CALENDAR ITEM

74

**CONSIDER APPROVAL OF PROPOSED REGULATORY AMENDMENTS
TO THE 2013 CALIFORNIA BUILDING CODE,
CALIFORNIA CODE OF REGULATIONS, TITLE 24, PART 2,
CHAPTER 31F – MARINE OIL TERMINALS**

FIGURE 31F-4-2
PILE-DECK CONNECTION MODELING FOR
PRESTRESSED CONCRETE PILE
(ADAPTED FROM [4.2])

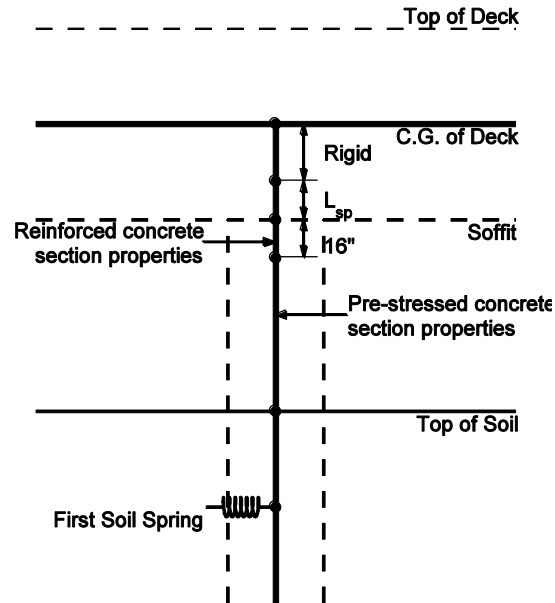
4.11. 3104F.2.3.1.1 Modeling. A series of nonlinear pushover analyses may be required depending on the complexity of the MOT structure. At a minimum, pushover analysis of a two-dimensional model shall be conducted in both the longitudinal and transverse directions. The piles shall be represented by nonlinear elements that capture the moment-curvature/rotation relationships for components with expected inelastic behavior in accordance with Section 3107F. The effects of connection flexibility shall be considered in pile-to-deck connection modeling. For prestressed concrete piles, Figure 31F-4-2 may be used. A nonlinear element is not required to represent each pile location. Piles with similar lateral force-deflection behavior may be lumped in fewer larger springs provided that the overall torsional effects are captured.

4.12. Add new Figure 31F-4-2:

FIGURE 31F-4-4
IDEALIZATION OF PUSHOVER CURVE (ADAPTED FROM [4.3])

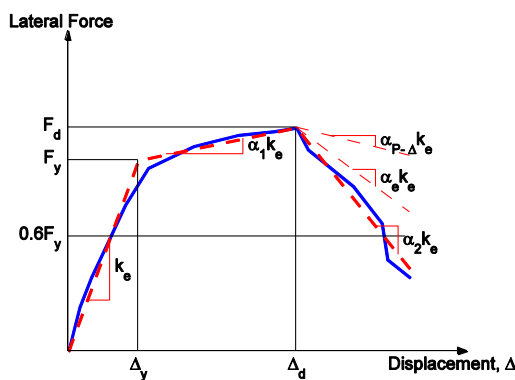
$\alpha_{P-\Delta}$, and the maximum negative post-elastic stiffness ratio, α_2 , are estimated from the idealized force-deformation curve, and λ is a near-field effect factor equal to 0.8 for sites with 1 second spectral value, S_1 greater than or equal to 0.6g and equal to 0.2 for sites with 1 second spectral value, S_1 less than 0.6g.

4.19. Add new Figure 31F-4-4:

FIGURE 31F-4-5
EFFECTIVE STIFFNESS, k_e [4.1]

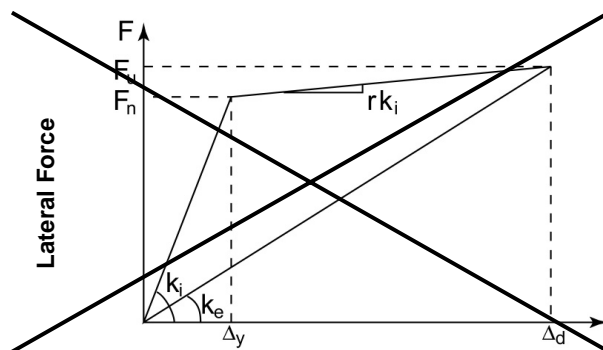
4.26. Remove entirely:

FIGURE 31F-4-9
PLAN VIEW OF WHARF SEGMENT UNDER X AND Y SEISMIC EXCITATIONS

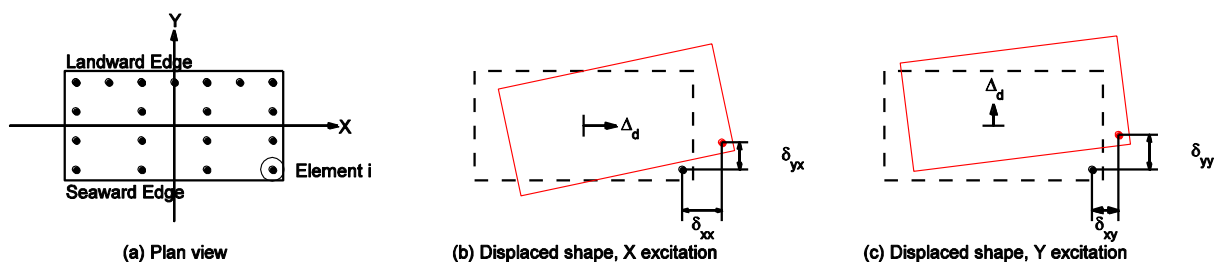
4.34. Remove entirely: **FIGURE 31F-4-7 PLAN VIEW OF WHARF SEGMENT UNDER X AND Y SEISMIC EXCITATIONS [4.3]**

4.35. Add new Figure 31F-4-9:

FIGURE 31F-6-1
AXIAL SOIL SPRINGS [6.8]

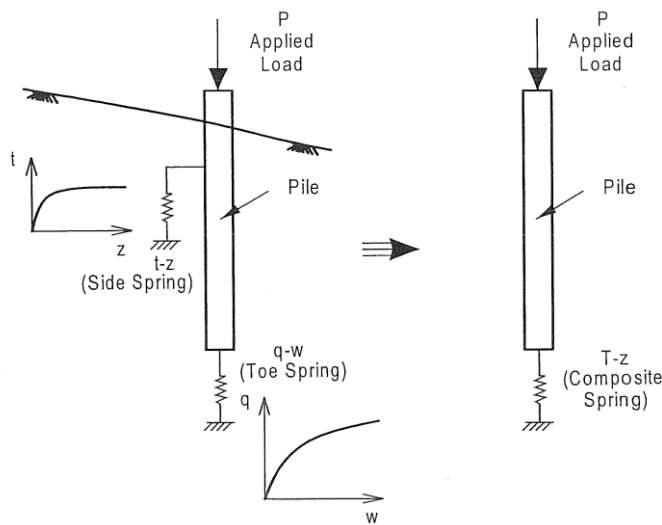
Due to the uncertainties associated with the development of axial springs, such as the axial soil capacities, load distributions along the piles and simplified spring stiffnesses, both upper-bound and lower-bound limits shall be estimated and utilized in the analyses.

6.23. Add new Figure 31F-6-1 :

FIGURE 31F-6-2
SLIDING LAYER MODEL [6.8]

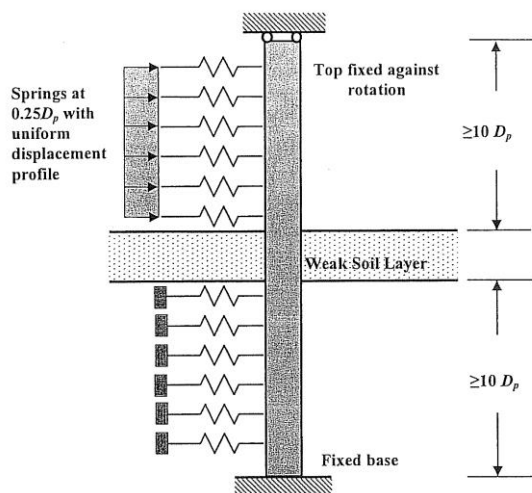
3. For a simplified analysis (see Figure 31F-6-2), the pile shall be fixed against rotation and translation relative to the soil displacement at some distance above and below the weak soil layer. Between these two points, lateral soil springs are provided, which allow deformation of the pile relative to the deformed soil profile.

6.29. Add new Figure 31F-6-2 :

FIGURE 31F-7-4
INFLUENCE OF PILE/SOIL STIFFNESS RATIO ON PLASTIC HINGE LENGTH (after Fig 5.30 of [7.1])

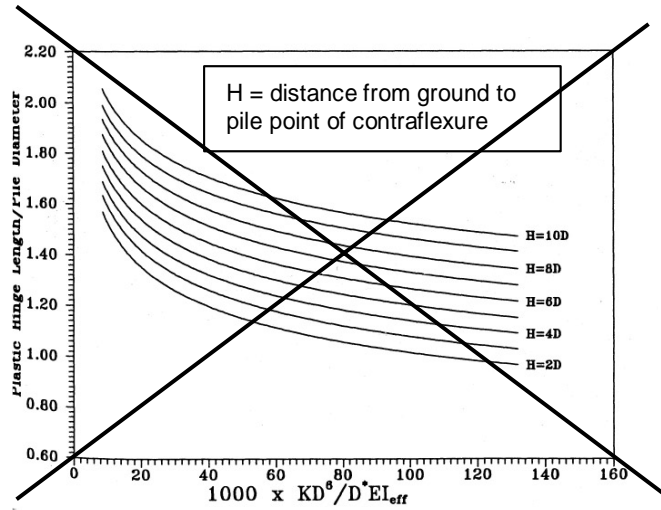
7.2. Remove entirely:

FIGURE 31F-7-4 31F-7-5
METHOD A – MOMENT CURVATURE ANALYSIS

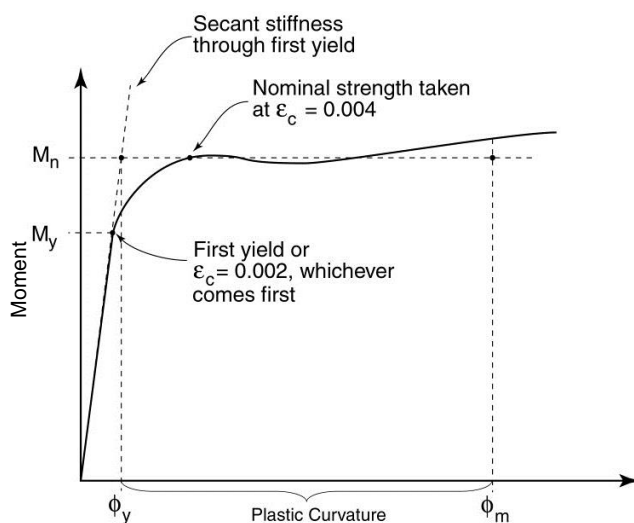
7.5. **3107F.2.5.4 Plastic rotation.** ~~The plastic rotation, θ_{pr} , can be determined from Equation 7-8, by using moment-curvature analysis and applicable strain limitations, as shown in Figure 31F-7-5.~~

7.7.

FIGURE 31F-7-5
METHOD B – MOMENT CURVATURE ANALYSIS [7.6]

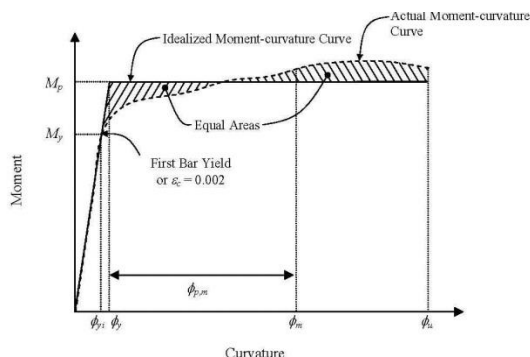
- 7.8. **3107F.2.5.4.2 Method B.** For Method B, the elastic portion of the idealized moment-curvature curve is the same as in Method A (see Section 3107F.2.5.4.1). However, the idealized plastic moment capacity, M_p , and the yield curvature ϕ_y , is obtained by balancing the areas between the actual and the idealized moment-curvature curves beyond the first yield point (see Figure 31F-7-5). Method B applies to moment-curvature curves that do not experience reduction in section moment capacity.

7.9. Add new Figure 31F-7-5:
